**ADDENDUM NO. 01****BILLINGS MET ADDITION AND REMODEL****1705 MONAD RD, BILLINGS, MT 59101**

Architect's Project No: 2329

Date Issued: 1-Mar-24

ARCHITECT: COLLABORATIVE DESIGN ARCHITECTS, INC.
2280 Grant Road – Suite C
Billings, Montana 59102
(406) 248-3443

1 MAIN FLOOR REFLECTED CEILING PLAN - REGION B - PARTS RECEIVING REMODEL

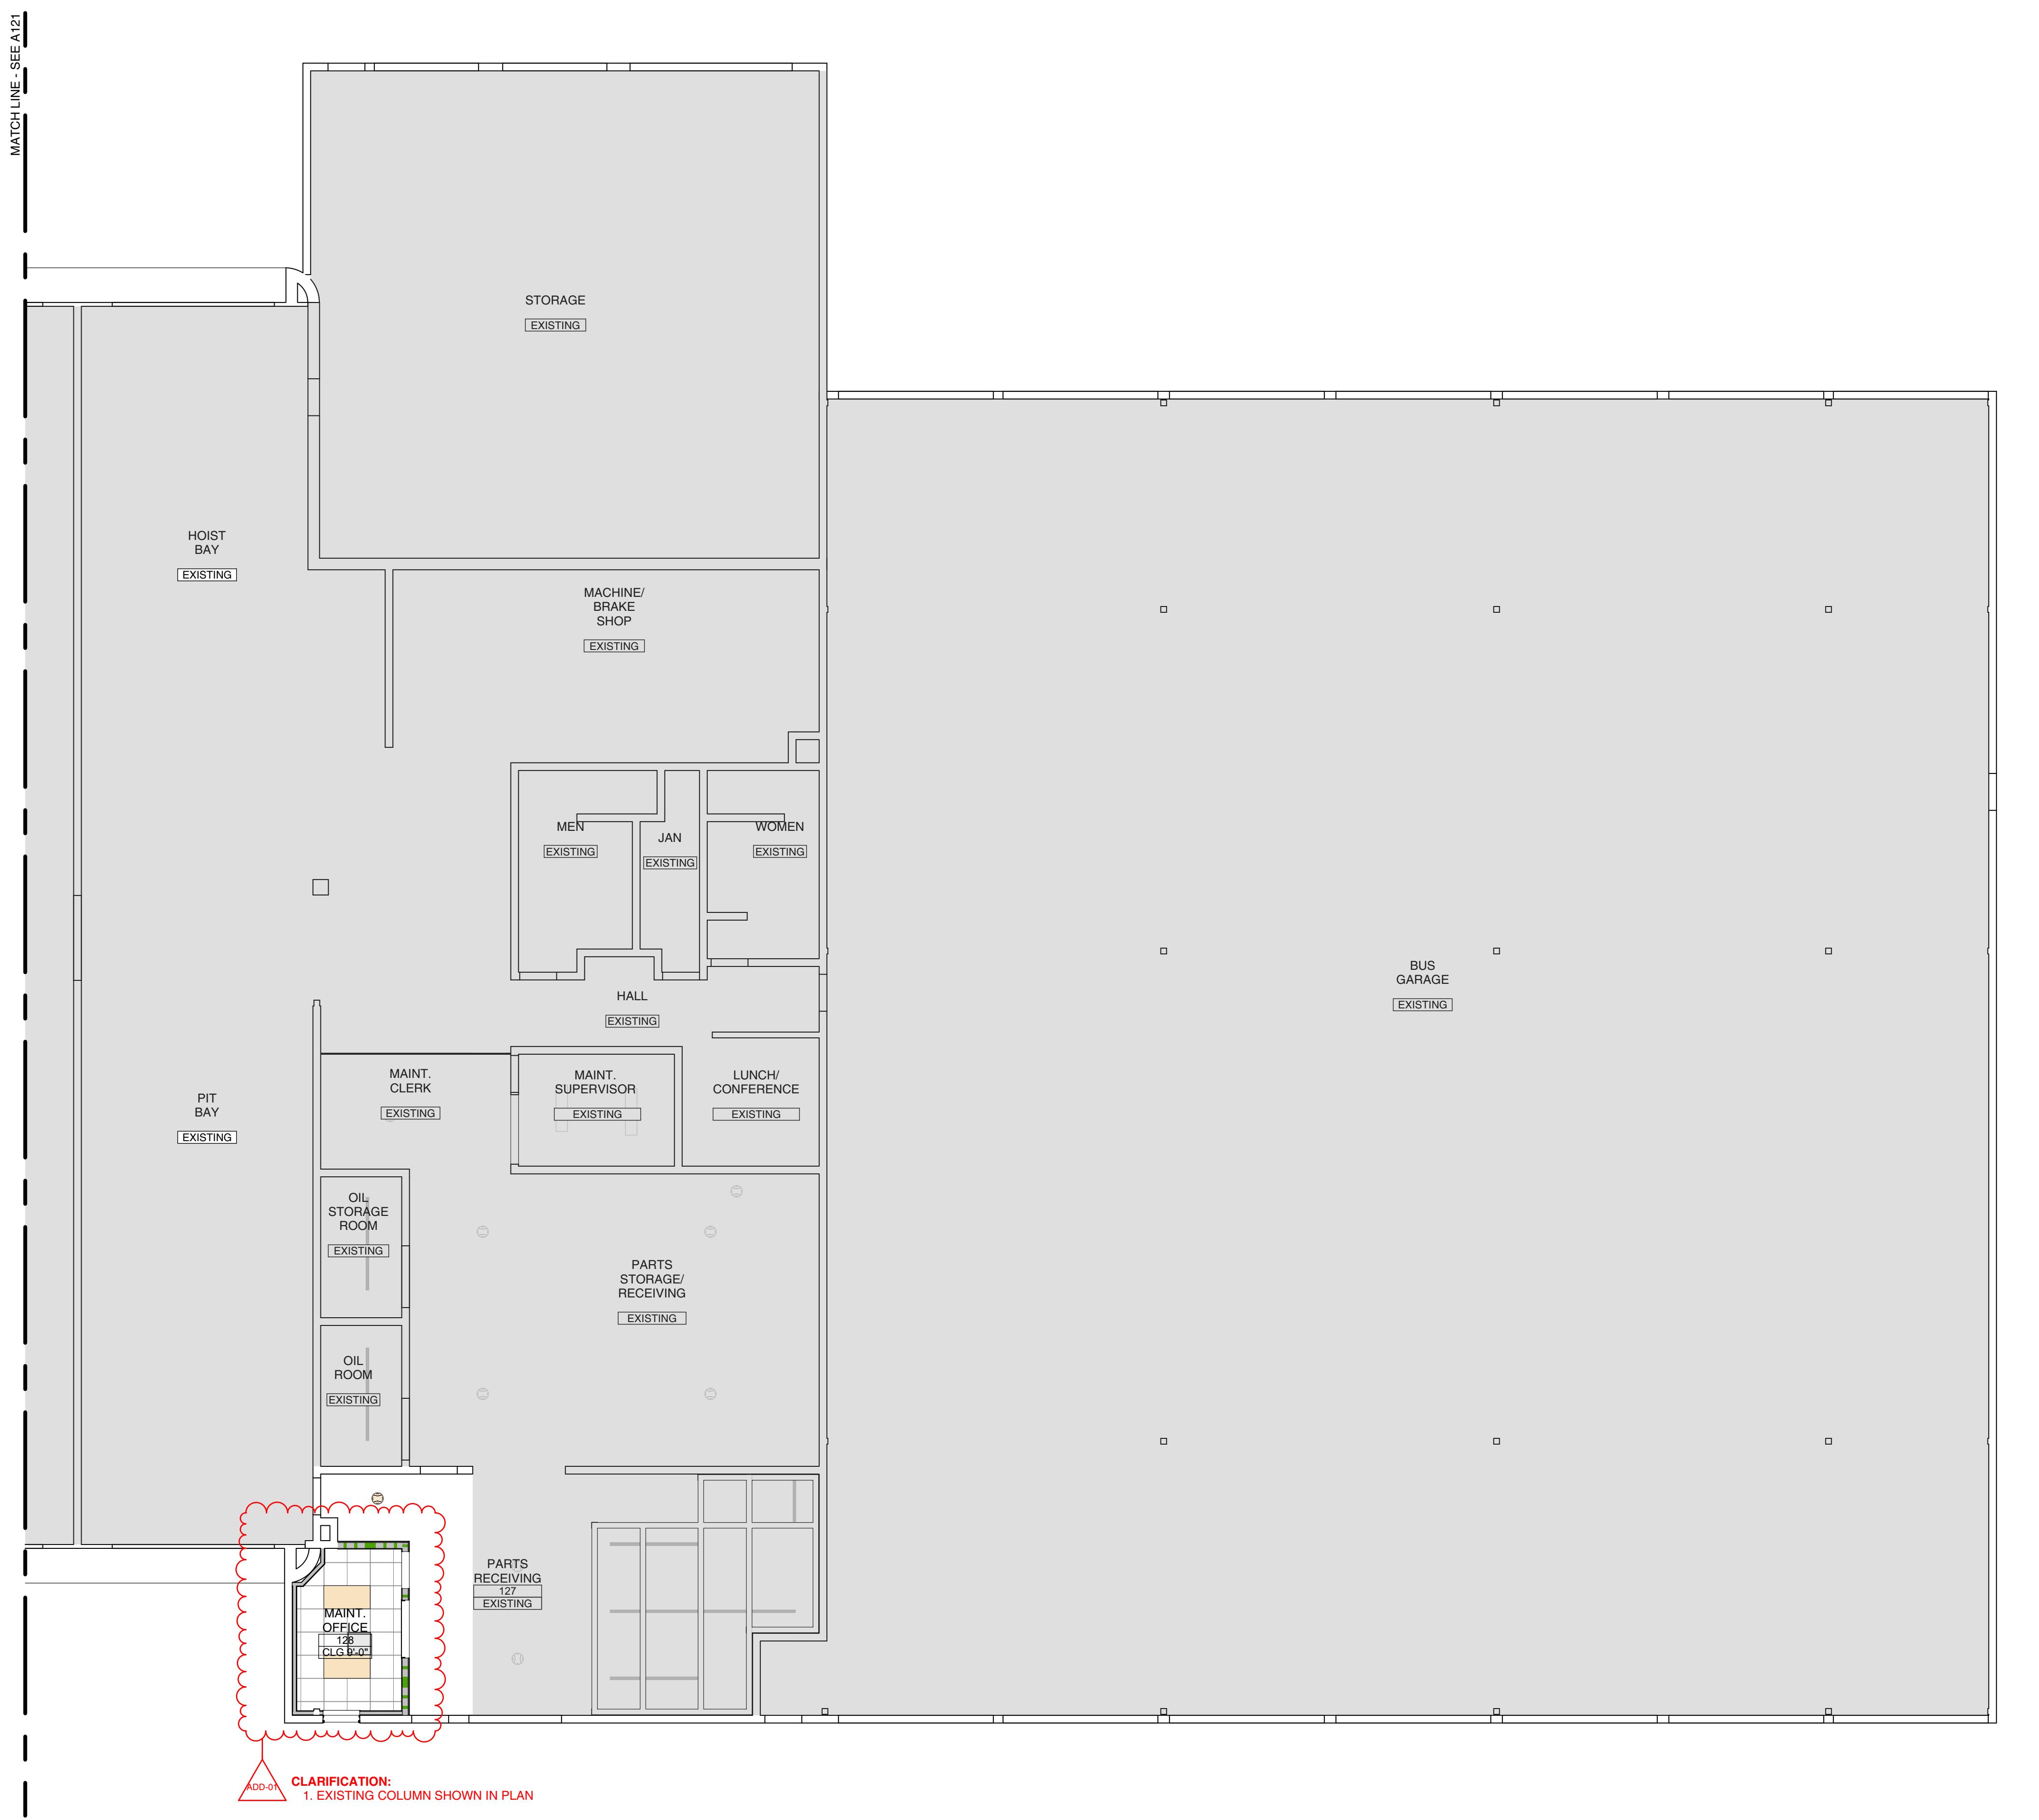
01.2.4	A103	REPLACE sheet in its entirety. Revisions are clouded. CLARIFICATION: 1. EXISTING COLUMN SHOWN IN PLAN
01.2.5	A122	REPLACE sheet in its entirety. Revisions are clouded. CLARIFICATION: 1. EXISTING COLUMN SHOWN IN PLAN

1 MAIN FLOOR FINISH PLAN - REGION B - PARTS RECEIVING REMODEL

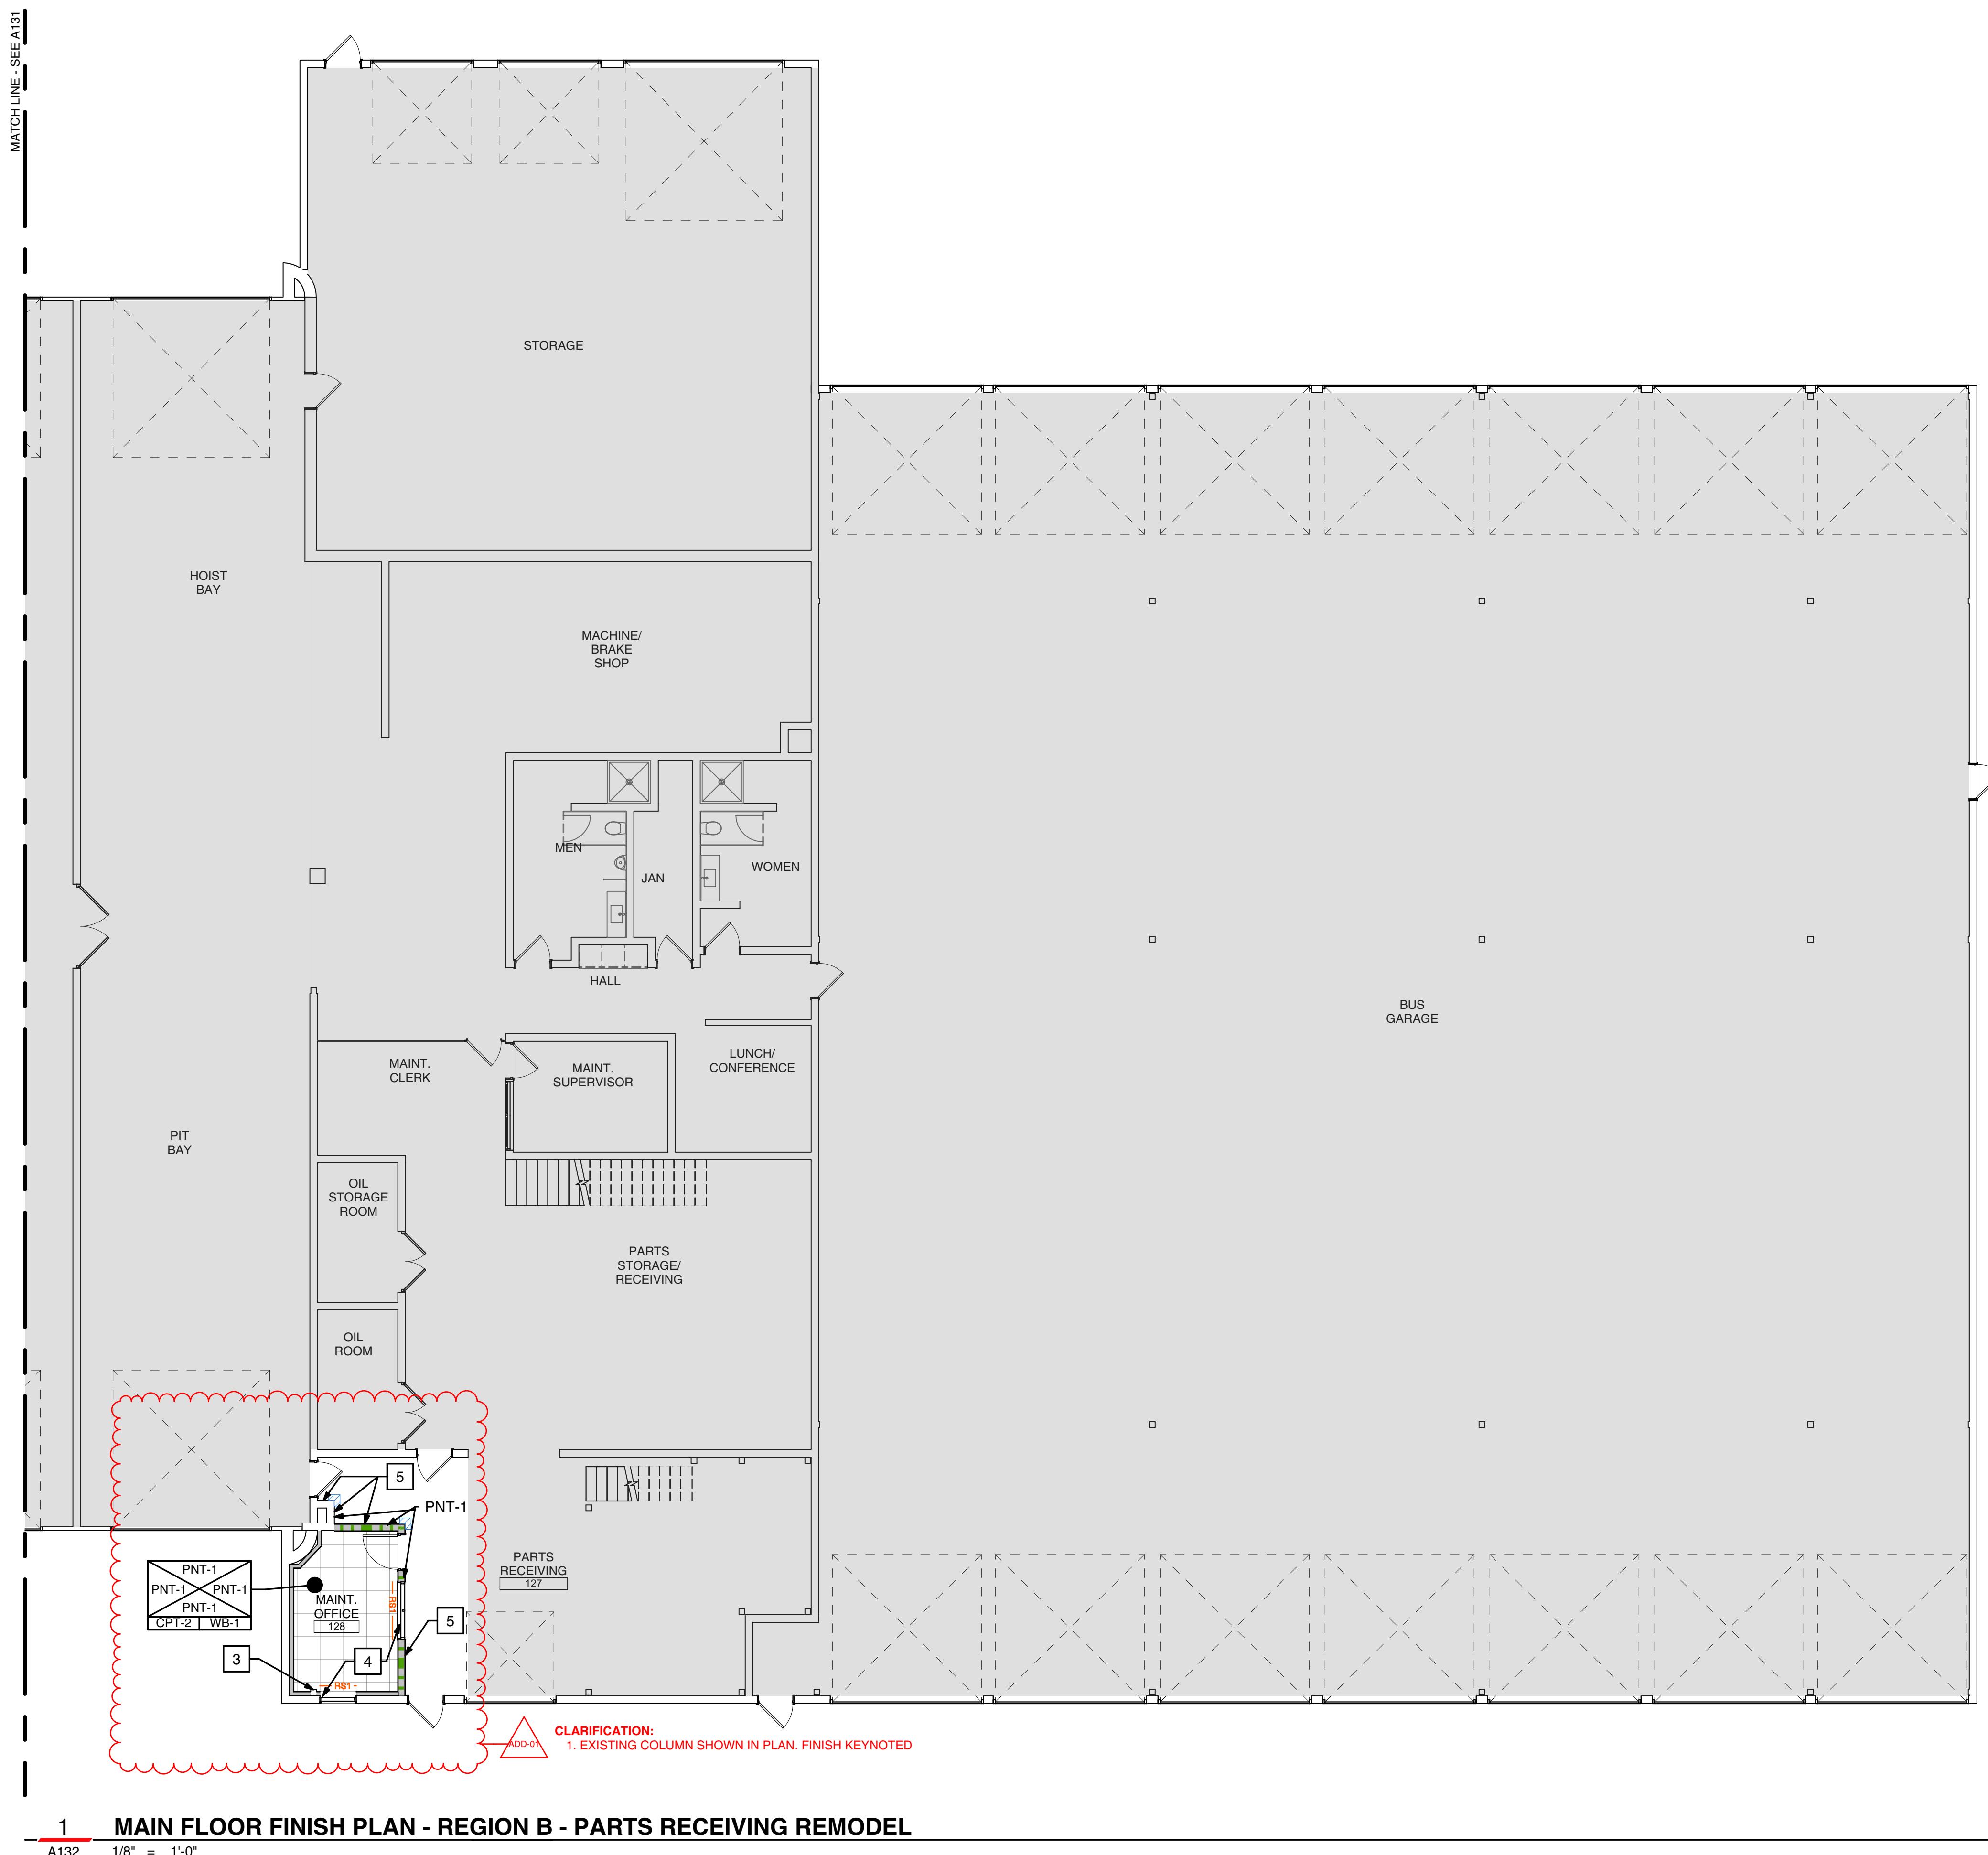
01.2.6	A132	REPLACE sheet in its entirety. Revisions are clouded. CLARIFICATION: 1. EXISTING COLUMN SHOWN IN PLAN. FINISH KEYNOTED
01.2.7	A143	REPLACE sheet in its entirety. Revisions are clouded. CLARIFICATION: 1. EXISTING COLUMN SHOWN IN PLAN
